**DOCUMENT 00 90 01
ADDENDUM #3**

Project: Provo City Airport Pump Station PROVOENG202320542

Date: Friday, December 2, 2022
Bid Date: Thursday, December 15, 2022
Bid Time: 10:00 a.m.

PROJECT NUMBER: 2019-0033
 SHEET OF: 29 OF 41
 SHEET NUMBER: E301

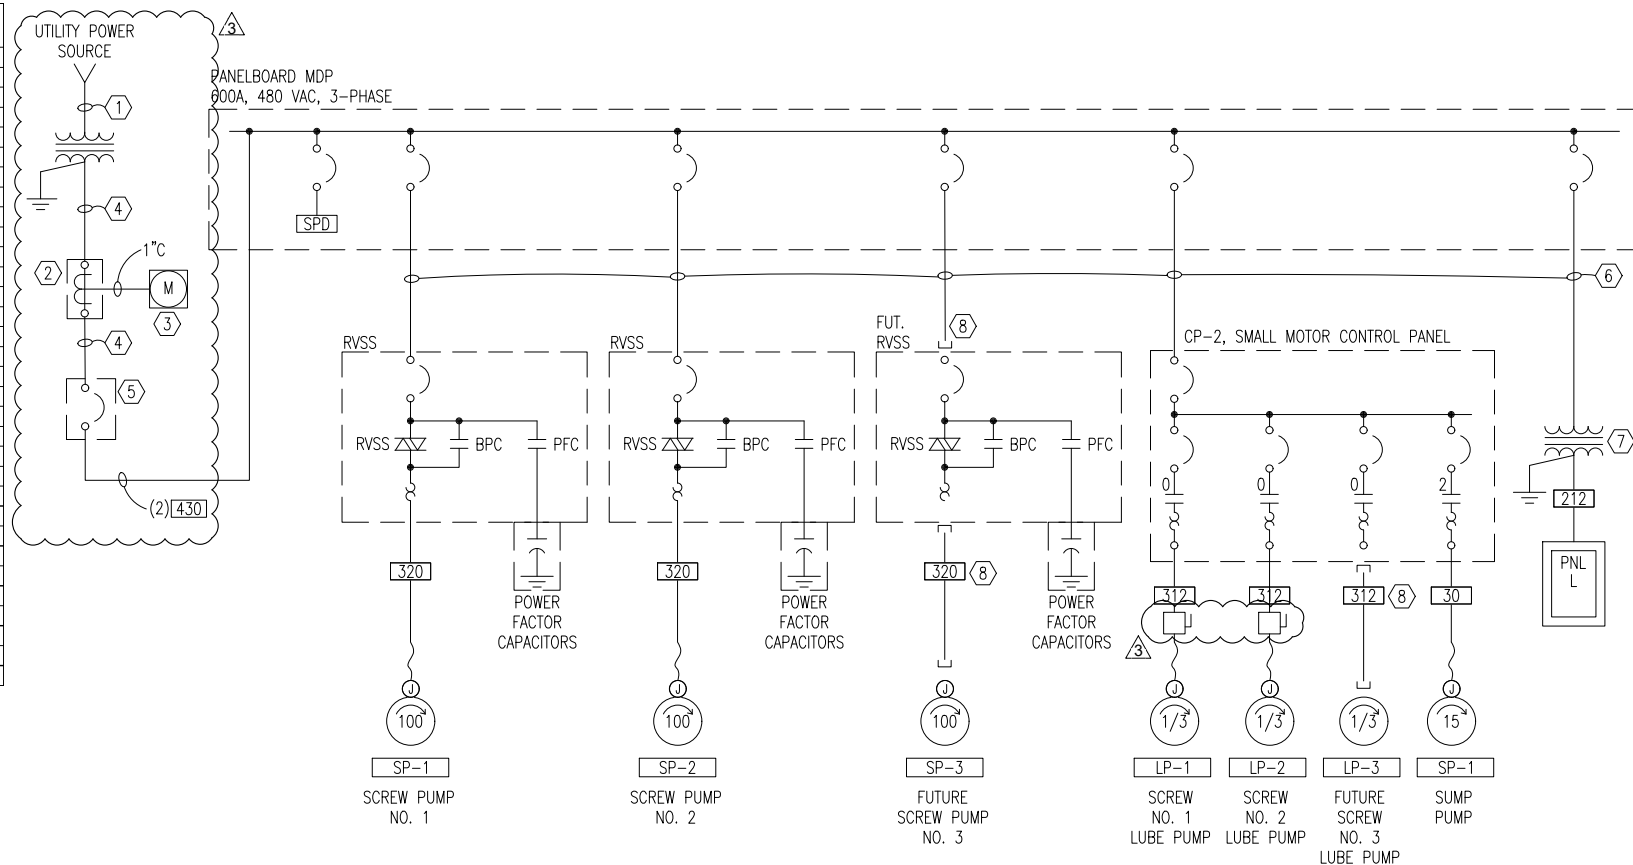
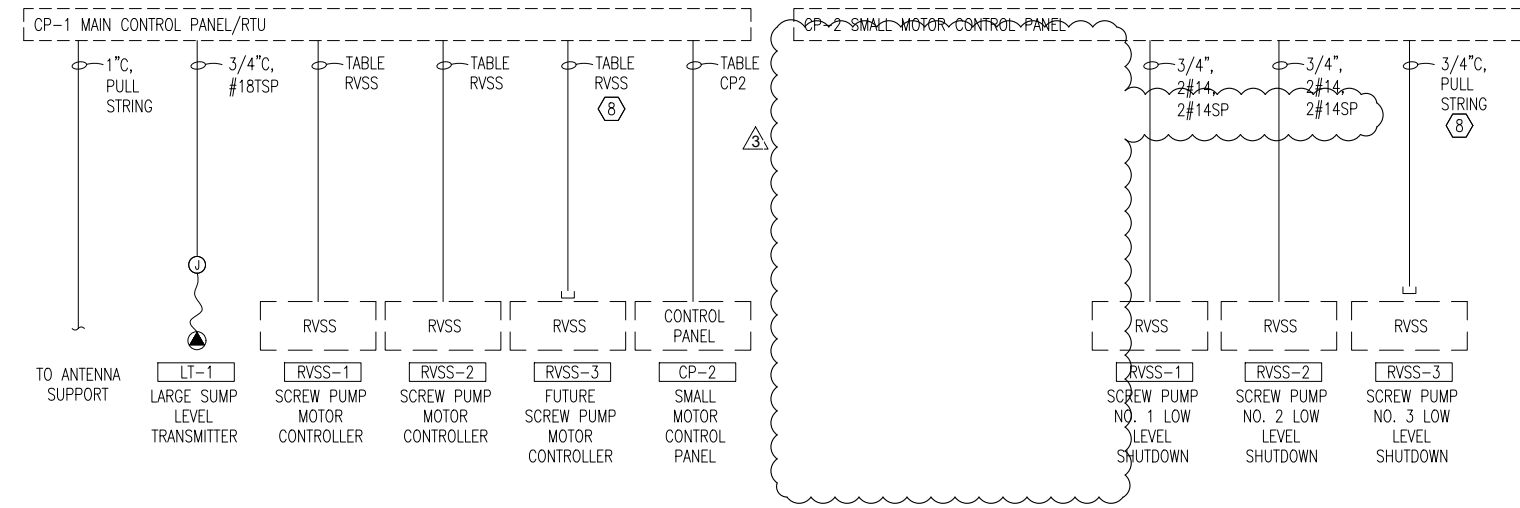
Delete and replace this sheet. Changes to the Power One-Line Diagram, Instrumentation and Control One-Line Diagram, and Table CP2. Added General Note #2. Changed Sheet Keynote #4.

PROJECT NUMBER: 2019-0033	SHEET OF 32	SHEET NUMBER E304
------------------------------	----------------	----------------------

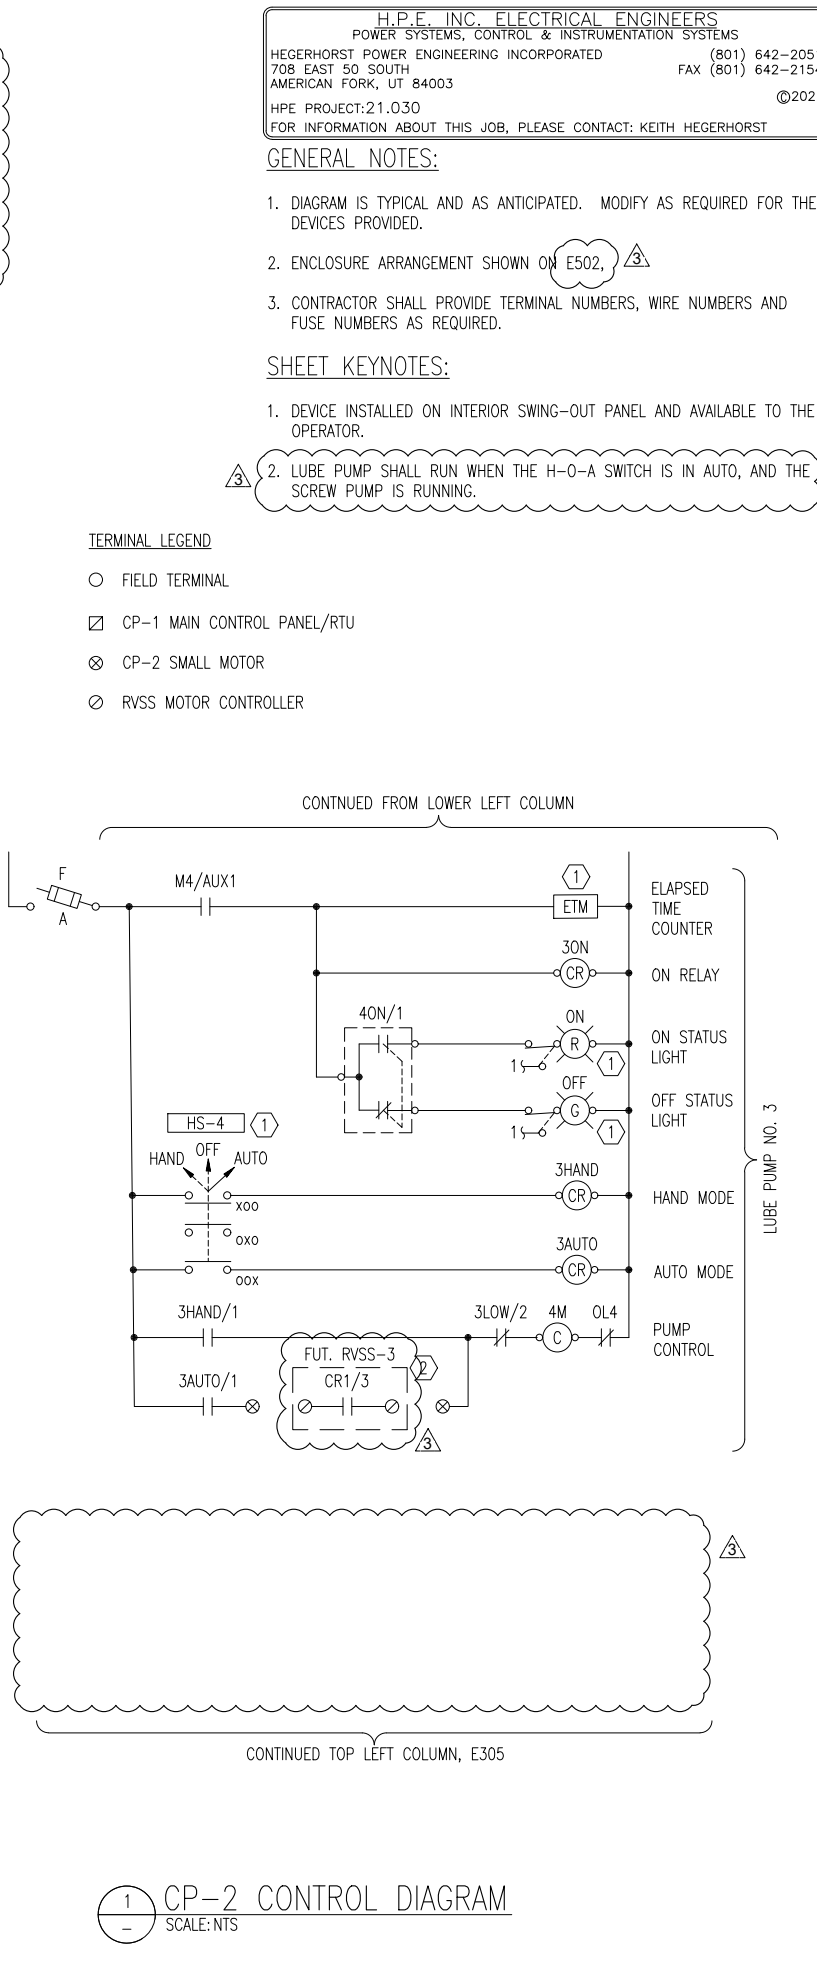
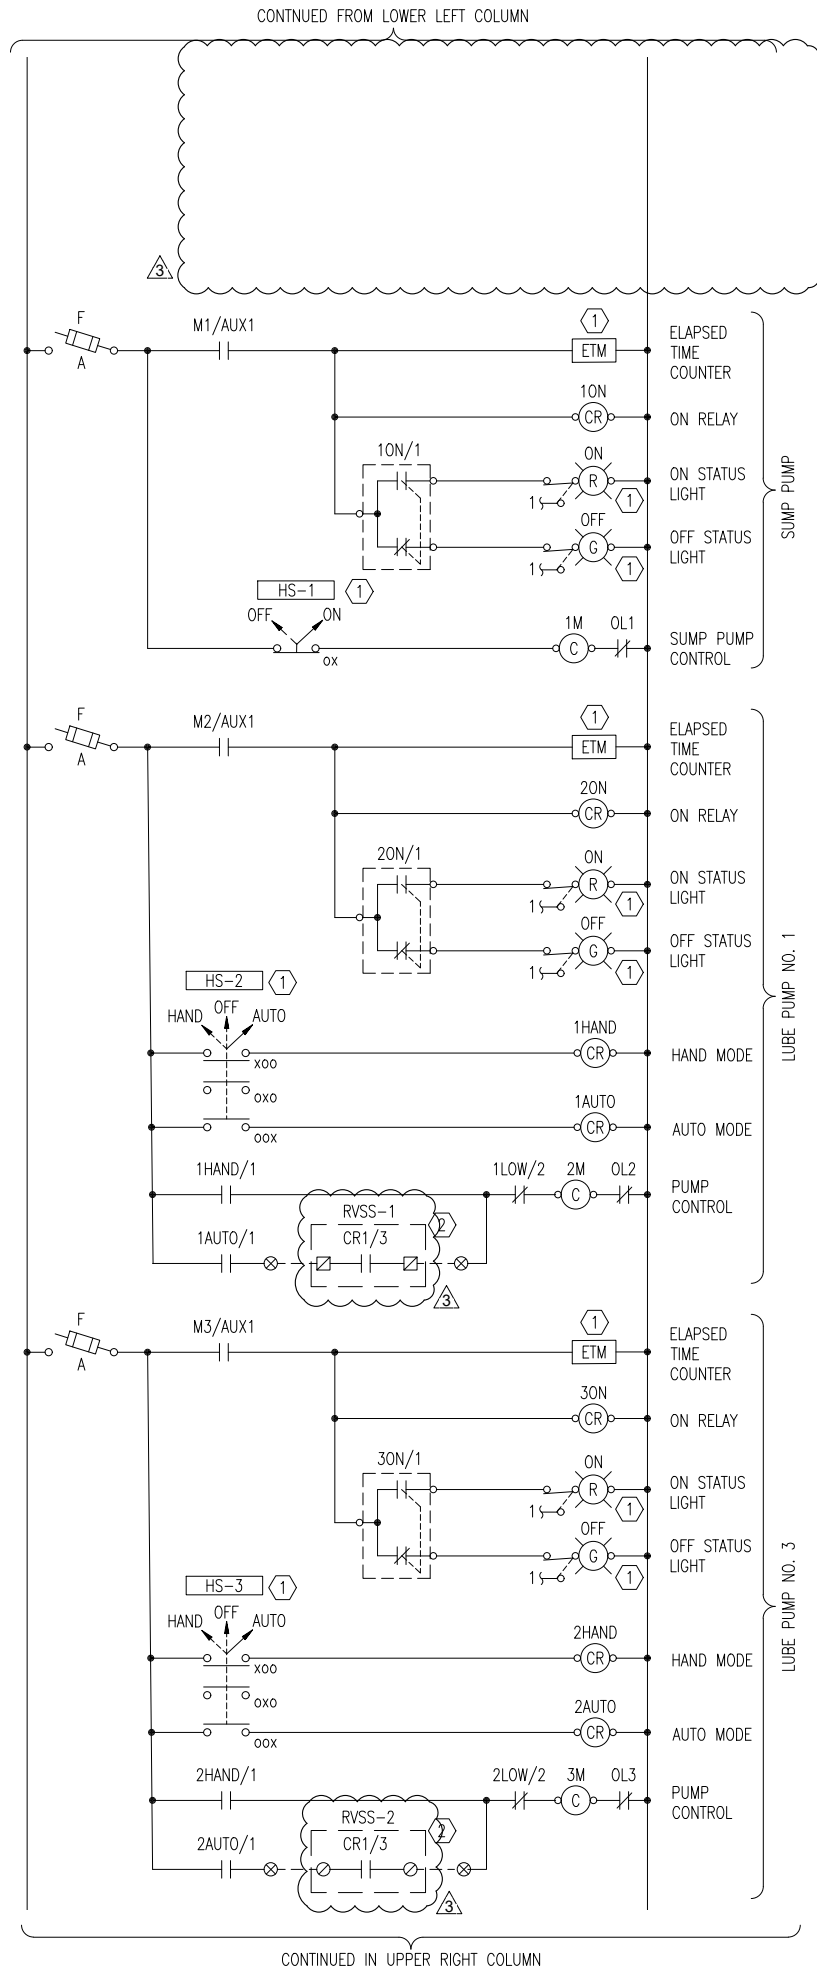
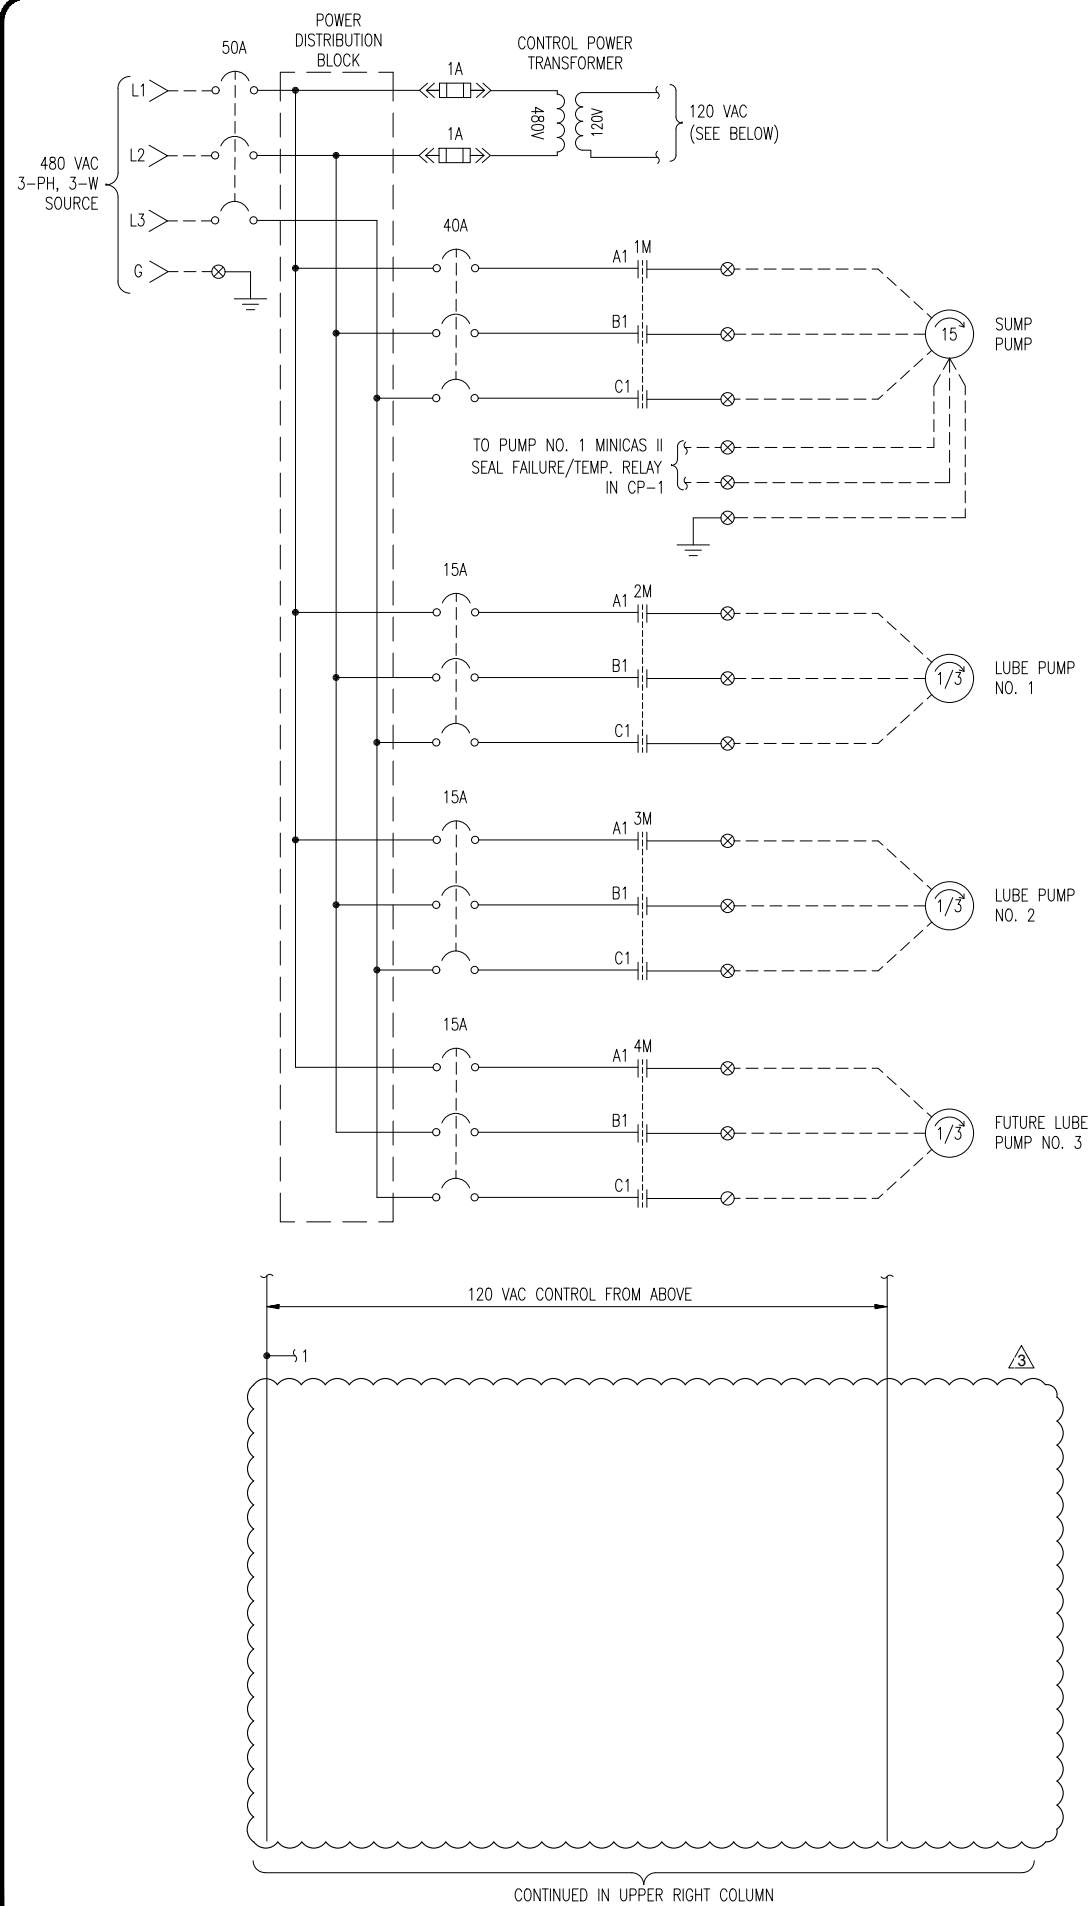
Delete and replace this sheet. Changes to the RVSS controls. Changed Sheet Keynote #2. Fixed General Note #2.

PROJECT NUMBER: 2019-0033	SHEET OF 35 41	SHEET NUMBER: E401
------------------------------	-------------------	------------------------------

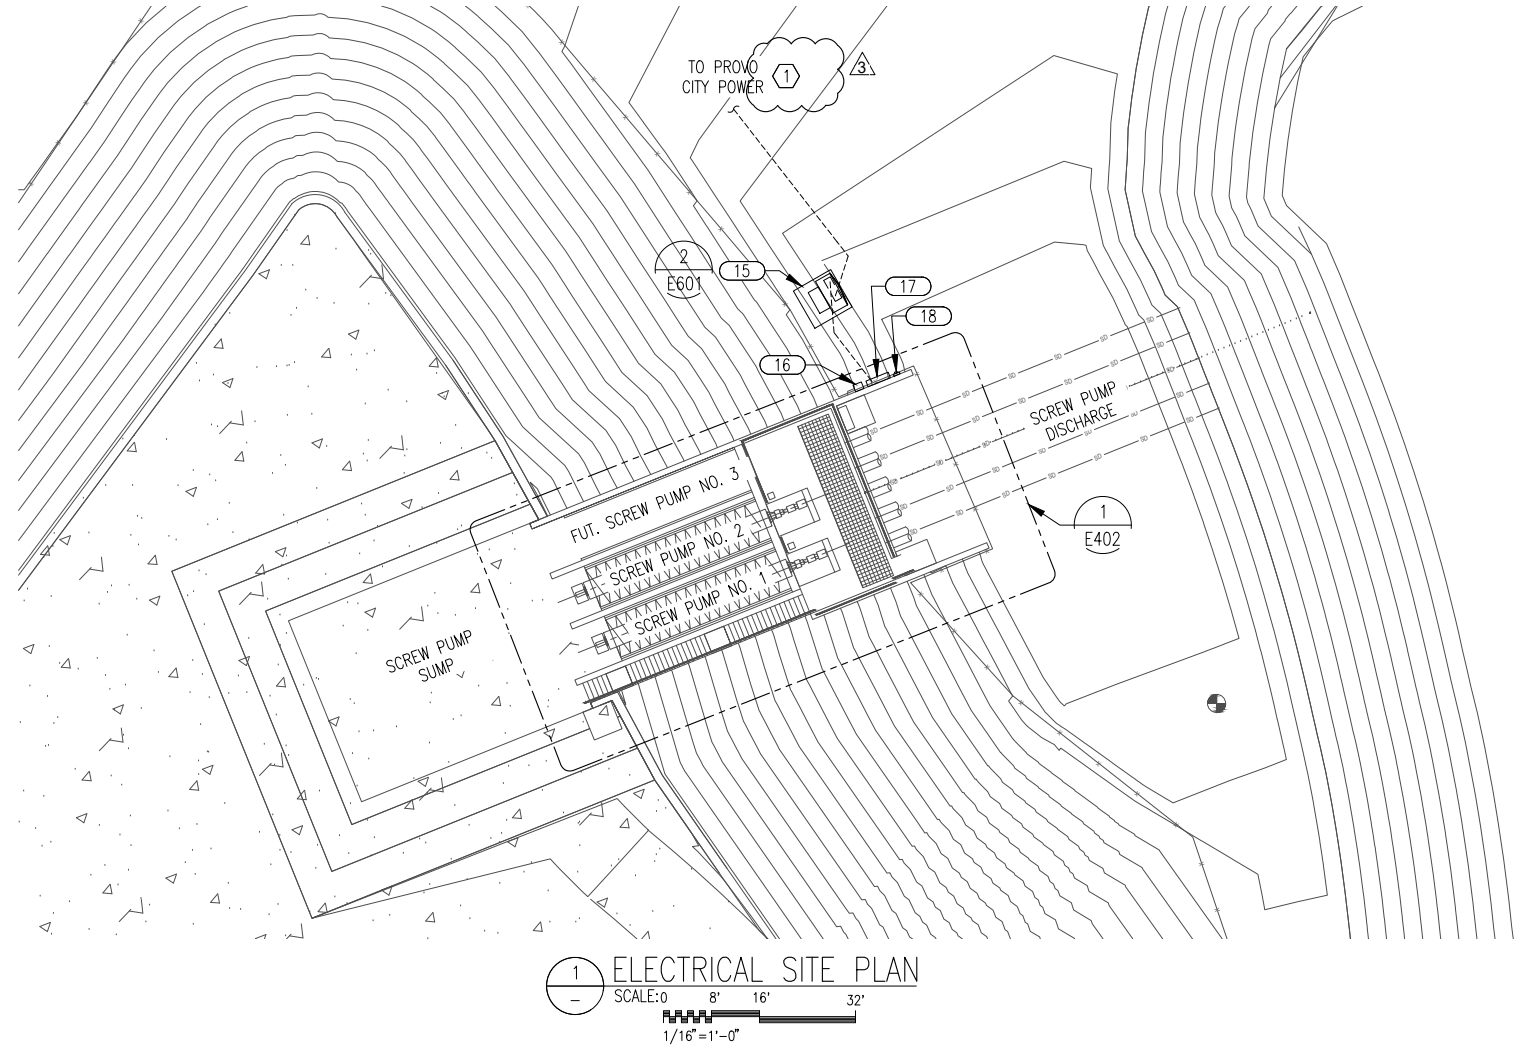
Delete and replace this sheet. Added more information the electrical conduit and power from Provo shown in Sheet Keynote #1.
